Technical Bulletin

Addition of Diode to Solenoid Circuits

Part No. 215735

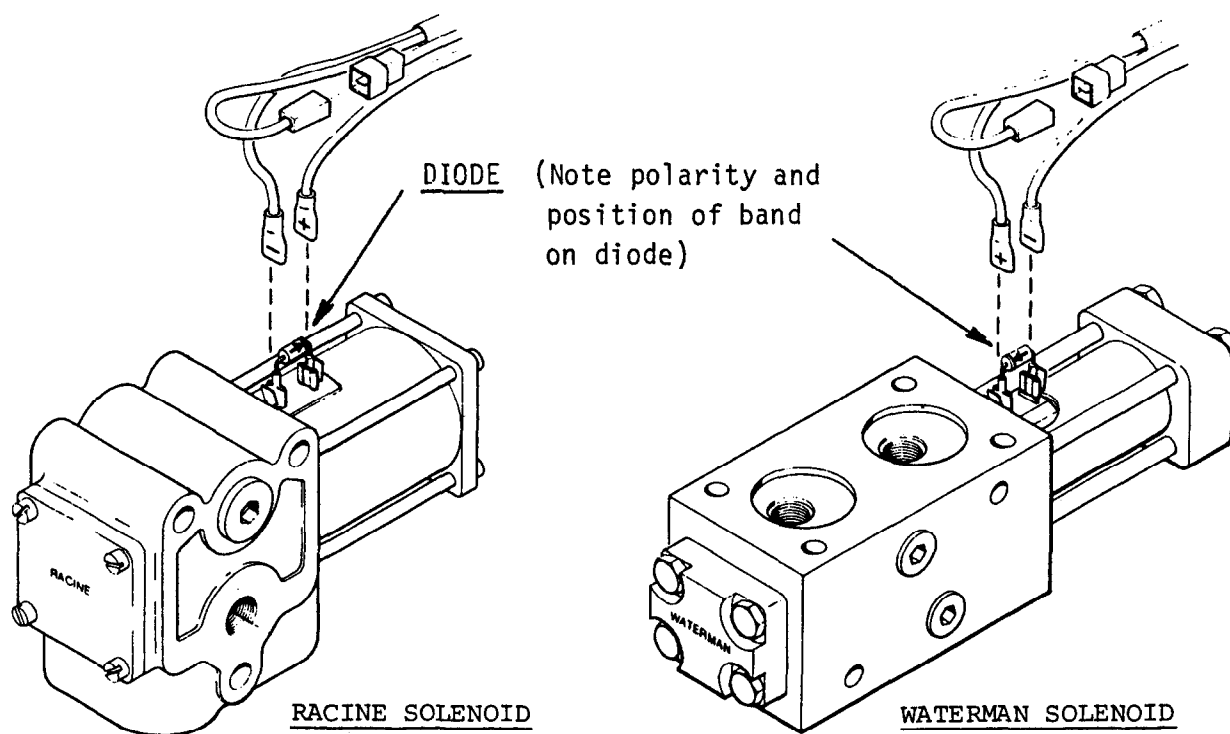
PROBLEM: Reverse polarity voltage spike occurs as solenoid control button is released, resulting in shortened service life of switch.

SOLUTION: Add diode to circuit at solenoid terminals to suppress voltage spike.

Cascade uses two solenoid types which are effected. Determine which solenoid terminal is positive and which is negative by testing switch circuit connections. Install diode with body band toward positive terminal. Reconnect solenoid wires in same location as originally installed.
